Vermont Yankee Nuclear Power Station

Proposed Technical Specification Change No. 263 – Supplement No. 9

Revised Containment Overpressure Envelope

VYC-0808, Revision 6, CCN 06

Figure 4.2 LOCA – Long Term (1.5 wt. % Containment Leakage & 100% Spray Efficiency)

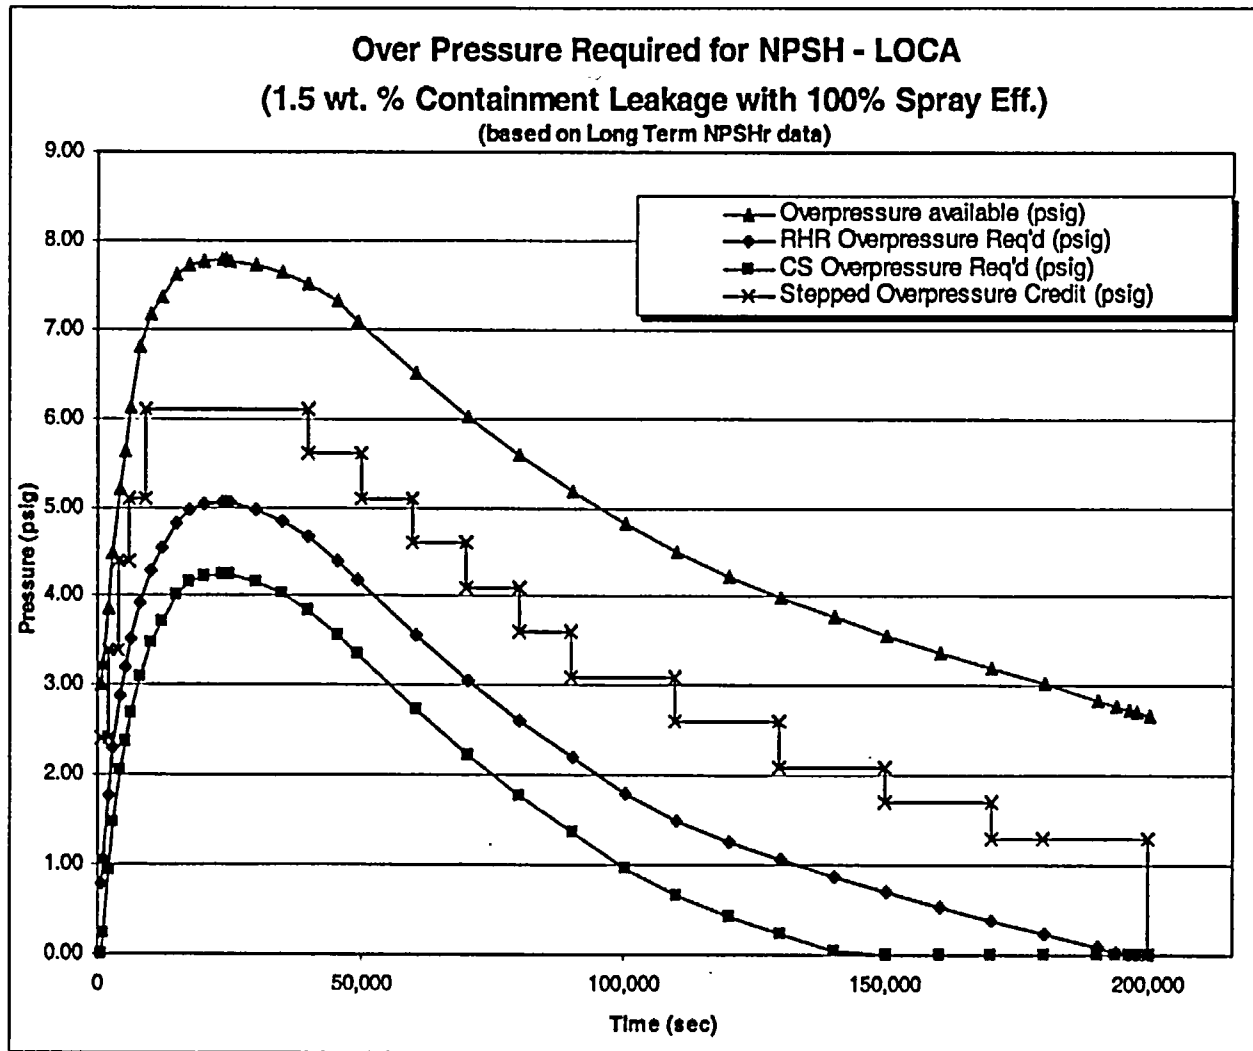
As can be seen from Figure 4.2 the overpressure required for RHR envelopes that required for CS and the overpressure varies continuously over time. In order to facilitate reporting and presentation of the overpressure required, an enveloping, stepped, overpressure credit is overlaid on Figure 4.2. Refer to Section 4.0 for discussion on selection of overpressure credit.

NPSHa is adequate for both CS and RHR pumps with an overpressure credit that varies over time, as shown in Fig. 4.2. NPSHa, OPR, OPC, OPA are shown below, at the peak temperature. The results remain unchanged from VYC-0808, Rev. 6, CCN05 (Ref. 12), LOCA long-term results, except for a slight reduction in Over Pressure Available (OPA).

OPC overpress credit	
(sec)	(psig)
601	2.4
2000	2.4
2001	3.4
4000	3.4
4001	4.4
6000	4.4
6001	5.1
9000	5.1
9001	6.1
40000	6.1
40001	5.6
50000	5.6
50001	5.1
60000	5.1
60001	4.6
70000	4.6
70001	4.1
80000	4.1
80001	3.6
90000	3.6
90001	3.1
110000	3.1
110001	2.6
130000	2.6
130001	2.1
150000	2.1
150001	1.7
170000	1.7
170001	1.3
180000	1.3
200000	1.3
200001	0
